Acorn Bioenergy Ltd: Construction and operation of an anaerobic digestion facility, associated infrastructure and new access road, connecting pipeline and covered digestate lagoons at Land to the north of Spring Grove Farm, Withersfield, Northwest of Haverhill, CB9 7SW

Review of Carbon Lifecycle Assessment and Development  
Embodied Carbon Assessment.

January 2025

Prepared by Henry Haworth – Brown & Co

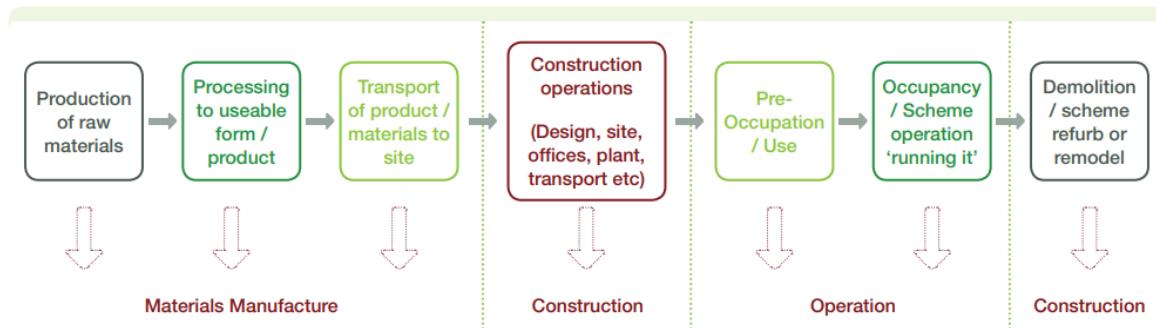
Through this assessment of operational emissions we have identified one area where these calculations could benefit from a small change to provide increased accuracy to the final figures. A consideration that digestate will not be available in the first year of production due to the lack of available digestate from the site, therefore that synthetic fertilisers should be considered to provide the required nutrients from crop growth in Year 1. The impact of these changes are presented in the table below.

This reassessment shows an increase of 825tCO2eq over the lifetime of the project, this equates to an increase of approximately 0.11% in emissions when compared to the figures presented by Acorn Bioenergy.
